# Notice of Intent Application

## Addendum

Revised, September 7, 2021

**Installation of two 30 ft meteorological observation towers on opposite ends of Clarks Cove**

## HEAVY WEATHER PLAN

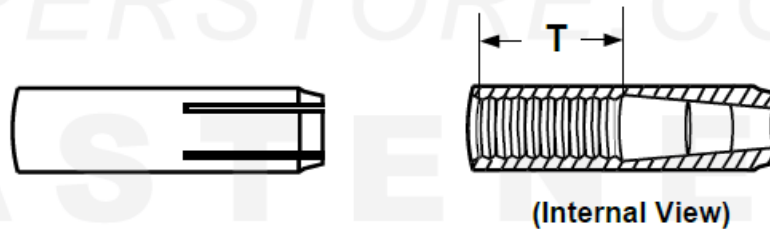
- **Provide a plan for how to secure and/or remove towers during major storm, including how to secure towers once tilted down. Even if the bases of the towers remain anchored, still need 30' end anchored/fastened in some way at both sites. Of particular concern is how the SMAST tower will be secured, either to rail or lying flat on pier.**

The project's licensed P.E. subcontractor, Waterfront Structural Consulting, LLC, has added to the tower installation drawing notes details regarding a "Heavy Weather Plan." For the SMAST location, this includes prescription of how to lower the tower to a horizontal position by removing a removable section of guard rail on the pier and securing the tower to rail brackets using 1,000 lb ratchet straps. For the Community Boating Center location, the notes including prescription of how to secure the tower using 1,000 lb ratchet straps to a stainless drop-in anchor point on the concrete deck that has been added to the construction design. Revised notes are attached on the following pages, and will be incorporated into the final design drawings for installation of the towers at the two proposed locations. Manufacturer drawings for the prescribed concrete anchor points and screw-eye are also included for reference. Additionally, the final hurricane preparation plan for tower decommissioning will be added to the existing UMassD/SMAST Severe Weather Plan in consultation with the SMAST Assistant Dean for Operations, and SMAST Facilities Manager. Finally, in addition to securing the towers themselves, the severe weather plan will include removing from the tower structures all electronics, batteries and sensors not specifically designed to withstand severe weather.

1. When winds are forecast to exceed 100 MPH within 48 hours, the following procedure shall be taken by SMAST to secure the towers.
  - a. Lower the tower to horizontal position with winch.
  - b. Support tower on timber blocking in a level position.

- c. At the Pier supported tower
  - i. Remove guard rail obstructing laydown of tower.
  - ii. Secure tower with 1000 lb. ratchet straps to the pier structure using the guard rail brackets.
  - iii. Store the removed guard rail indoors.
  - iv. Provide rope across the removed section of guard rail
- d. At the Jetty supported tower
  - i. Secure the tower with 1000 lb. capacity ratchet straps to stainless steel drop-in anchor point on concrete deck.
